SAFETY EVALUATION BY THE OFFICE OF NUCLEAR REACTOR REGULATION  
RELAXATION REQUEST FROM ORDER EA-03-009 REGARDING THE  
EXAMINATION COVERAGE FOR REACTOR PRESSURE VESSEL HEAD  
INCORE INSTRUMENTATION PENETRATION NOZZLES  
FACILITY OPERATING LICENSE NO. NPF-6  
ENTERGY OPERATIONS, INC.  
ARKANSAS NUCLEAR ONE, UNIT 2  
DOCKET NO. 50-368

## 2.0 RELAXATION REQUEST FROM EXAMINATION COVERAGE FOR RPV HEAD ICI PENETRATION NOZZLES, ORDER EA-03-009

**Figure 1**

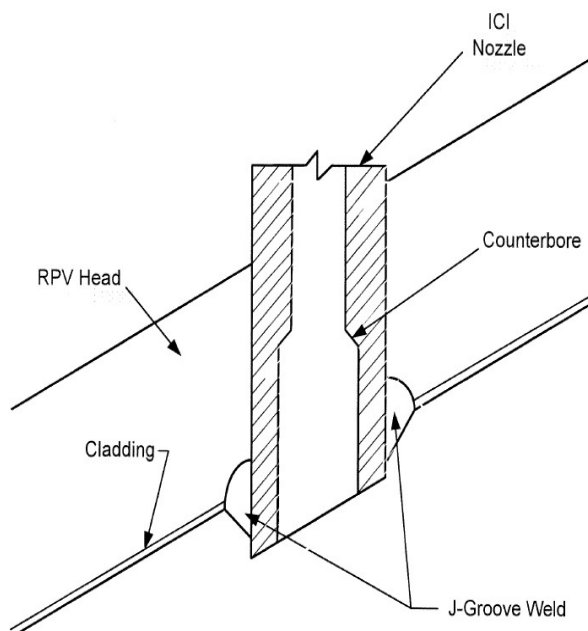
The licensee states that the ICI nozzles are manufactured with a counterbore above the J-groove weld (Figure 1). According to the licensee, because of UT transducer liftoff of at the counterbore, a UT blind zone exists at the upper hillside location (180° azimuth) of each ICI nozzle. The licensee describes the dimensions of the blind zone as measuring approximately 0.88 inch in axial length, with the bottom of the blind zone located 1.080 inches above the top of the J-groove weld. The licensee states that the portion of the counterbore blind zone that lies within the required inspection zone of 2-inches above the J-groove weld is centered at the upper hillside location of each nozzle, and has a circumferential extent of 82°. According to the licensee, the blind zone associated with the counterbore does not exist at any other azimuthal location along the circumference of the ICI nozzle within the required 2 inch inspection area above the J-groove weld. The licensee states that the counterbore is significantly closer to the J-groove weld on the upper hillside of the nozzle than on the lower hillside, due to the RPV head angle at the ICI locations. The licensee also states that no volumetric inspection equipment is available to inspect the counterbore region, and resolving the UT limitations due to the counterbore would require eliminating the counterbore region through a physical modification of the nozzle itself. Entergy further states that it does not have the equipment necessary to perform such a modification.

The ICI nozzles differ from CEDM nozzles by having a counterbore with an axial length of 0.25 inch and a taper of 1 to 4 (radial depth to length), located at 1.080 inch from the top of the J-groove weld. The blind zone is caused by the lift-off of the UT transducer sled over the

counterbore during scanning. Since the licensee did not model the counterbore region with a mesh size that could account for stress increases, the staff requested the licensee to provide an error assessment. In response to the NRC staff's concern, the licensee provided additional information in its letter of September 26, 2003, which is based on additional FEM analyses on nozzles with and without a counterbore, where an adequate mesh was used for the counterbore region. The results indicate that the maximum axial stresses increase by 25% to 30%, while the hoop stresses stay approximately the same. The NRC staff considers this finding reasonable because geometric discontinuity is only seen in the axial direction of the ICI nozzle with a counterbore, not the circumferential direction. The NRC staff addresses the significance of the higher axial stresses in its evaluation of the licensee's fracture mechanics analysis, as described below. With the stress issue specific to ICI nozzles addressed appropriately by the licensee, the staff finds that the FEM modeling for the ICI nozzles is adequate, and the resulting stresses can be used as input to the licensee's fracture mechanics evaluation.

The NRC staff finds that the licensee's proposed alternative examination of the ICI RPV head penetration nozzles, including its crack growth analysis to justify not inspecting the blind zone in the counterbore region, provides reasonable assurance of structural integrity of the RPV head, VHP nozzles, and welds. Further inspection of the ICI nozzle counterbore region in accordance with Section IV.C.(1)(b)(i) of Order EA-03-009 would result in hardship without a compensating increase in the level of quality and safety.

**Figure 2**

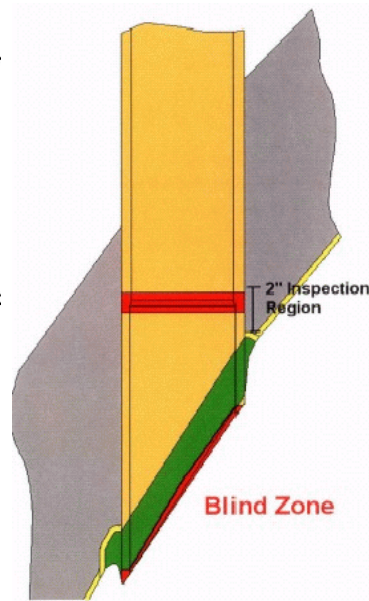
The licensee stated that it will perform a UT examination from the inside diameter (ID) of each ICI nozzle (i.e., nozzle base material) in accordance with Section IV.C(1)(b)(i) of the Order, with the exception of the blind zone at the bottom of each ICI nozzle, and the blind zone in the counterbore region above the J-groove weld of each ICI nozzle. For illustration purposes, Figure 1 shows the ICI nozzle configuration, and Figure 2 shows the location of the blind zones. Figure 1 was taken from the licensee's September 24, 2003, letter, and Figure 2 was taken from the licensee's presentation that it gave at NRC headquarters on August 14, 2003.
